SUBJECT: Application for amends to Licenses DPR-58 & DPR-74, modifying
 Tech Spec Table 3.3-3. Fee paid.

Donald C. Cook Nuclear Plant Units 1 and 2
Docket Nos. 50-315 and 50-316
License Nos. DPR-58 and DPR-74
TECHNICAL SPECIFICATION CHANGE:
MOTOR-DRIVEN AUXILIARY FEEDWATER ACTUATION SIGNALS

Attachment 1 to AEP:NRC:1030A
Reasons and 10 CFR 50.92 Analyses for Changes to the
Donald C. Cook Nuclear Plant
Units 1 and 2 Technical Specifications

Figure 1 Donald C. Cook Nuclear Plant auxiliary feedwater system

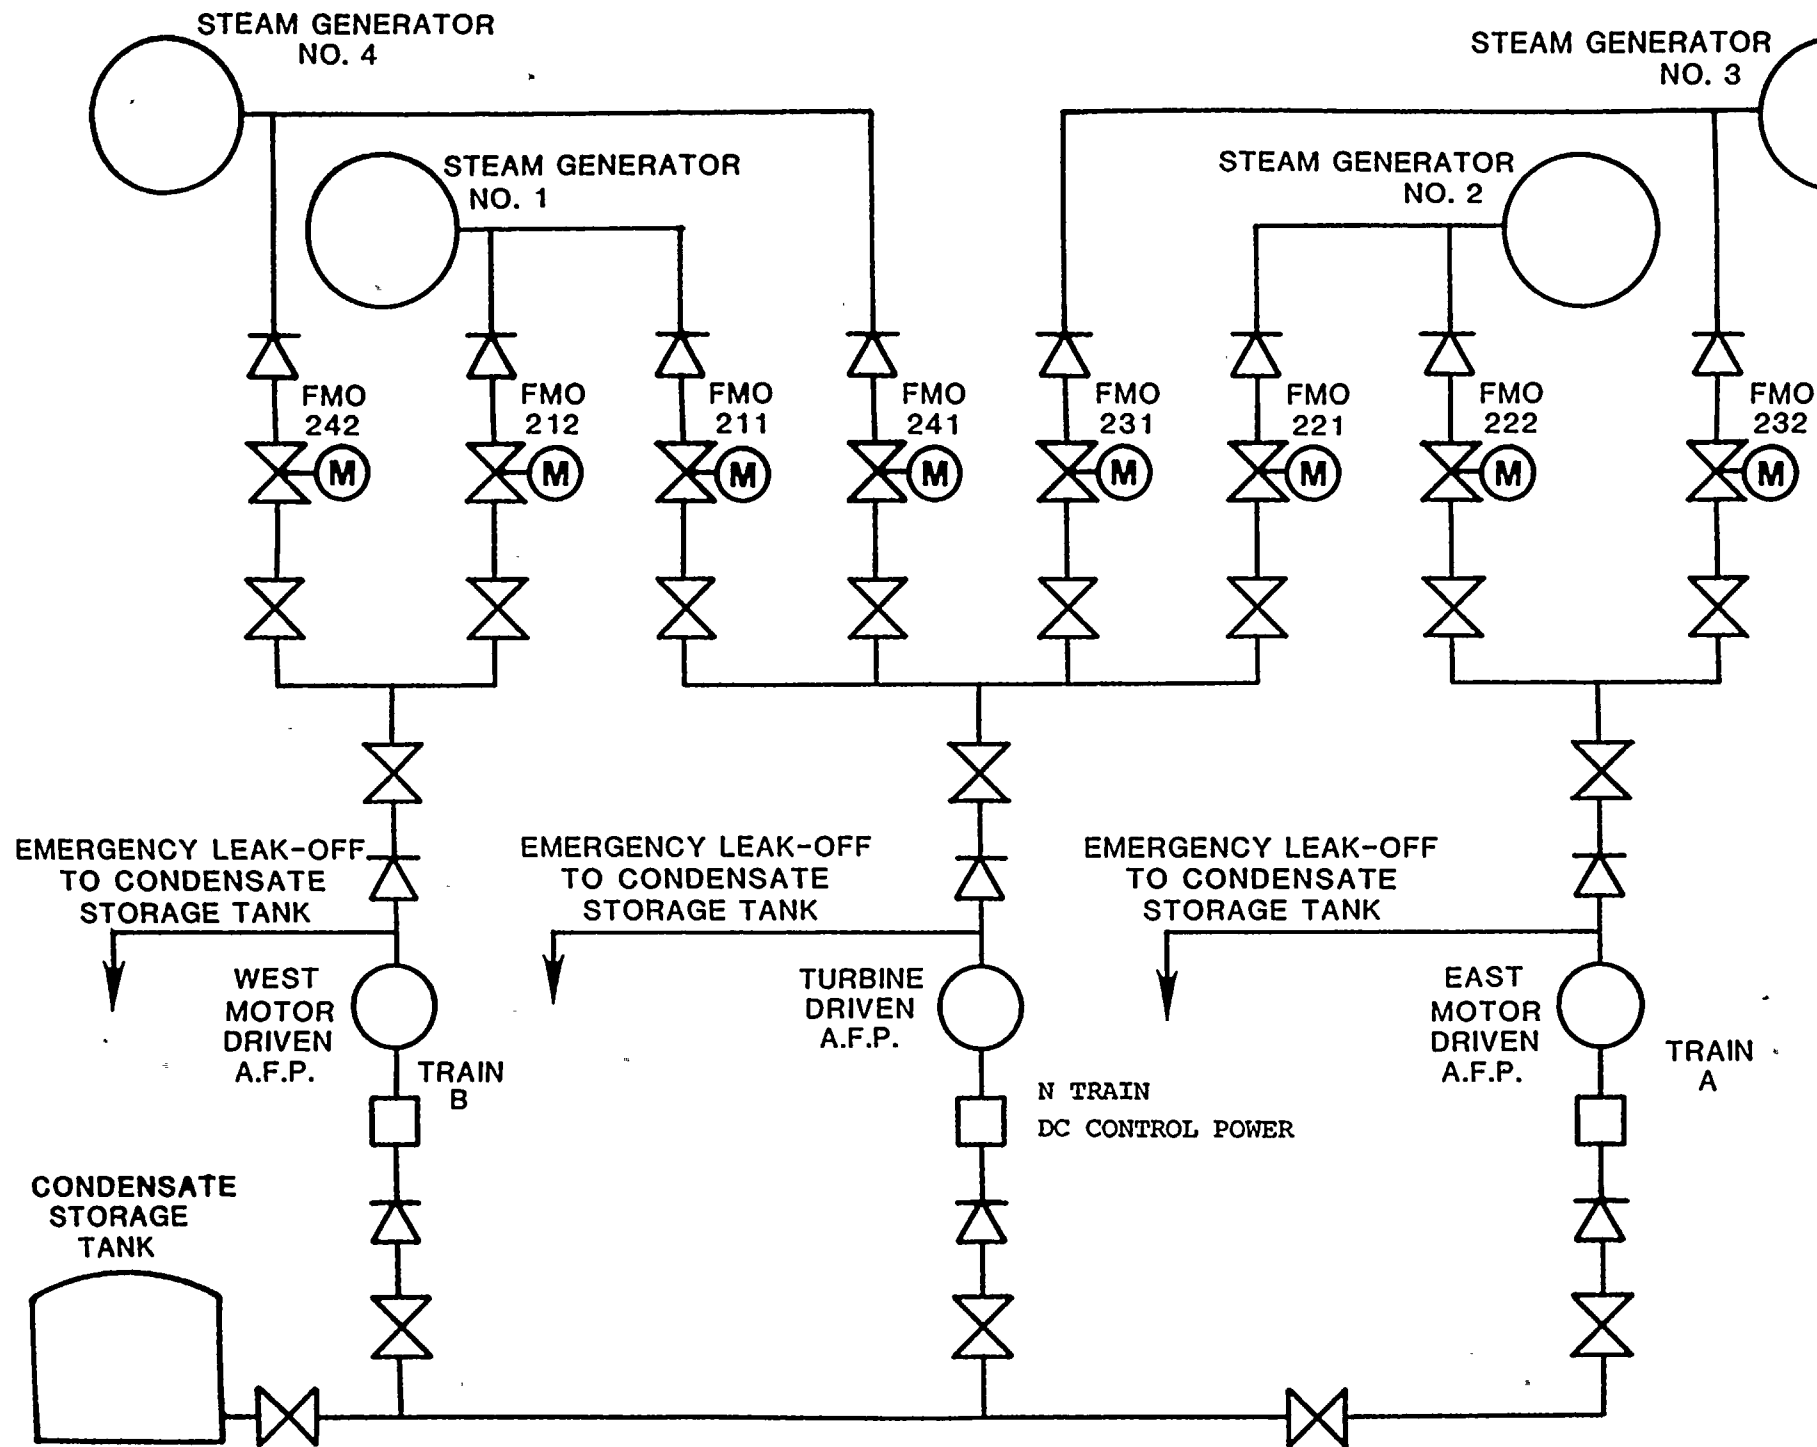
A schematic drawing of the motor driven auxiliary feedwater pump system at the Cook Nuclear Plant is presented in Figure 1 of this attachment. As indicated in the figure, the Train A (East) pump delivers flow to Steam Generator No. 2 via motor operated valve FMO-222, and to steam generator No. 3 via FMO-232. Likewise, the Train B (West) pump delivers flow to steam generator No. 1 via FMO-212, and to steam generator No. 4 via FMO-242.

Figure 2 Power sources for motor driven auxiliary feedwater pumps and associated valves

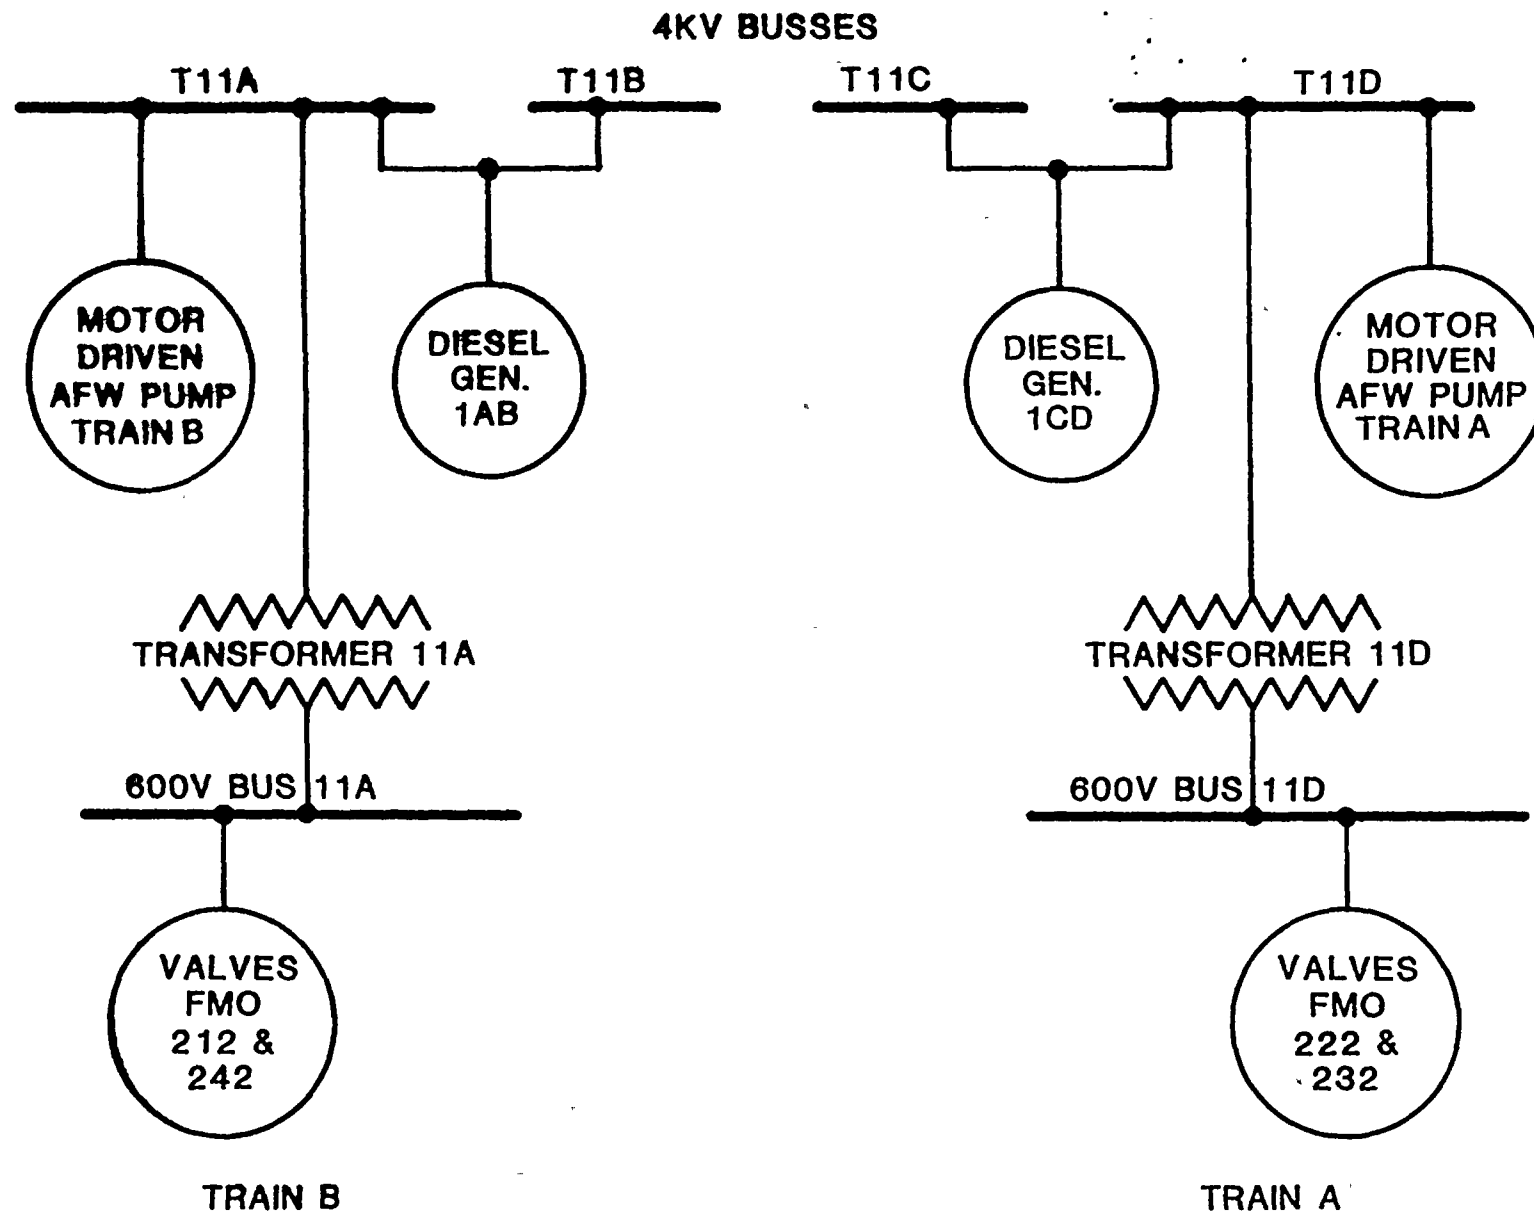
A schematic drawing of the electrical bus arrangement with regard to the motor driven auxiliary feedwater pumps and their associated motor operated valves is provided as Figure 2. As indicated in the figure, the Train B pump is powered from the 4kv bus T11A. The valves associated with the Train B pump are powered from the 600-volt bus 11A, which is fed from bus T11A. The Train A pump and valves are similarly fed from 4kv bus T11D and 600-volt bus 11D, respectively.

There are 3 relays (channels) which indicate loss of voltage on each of the 4 safety busses. Actuation of 2 of the relays on bus T11A will start an emergency diesel generator and the Train B motor driven auxiliary feedwater pump. Similarly, actuation of 2 of the relays on bus T11D will start an emergency diesel generator and the Train A pump.
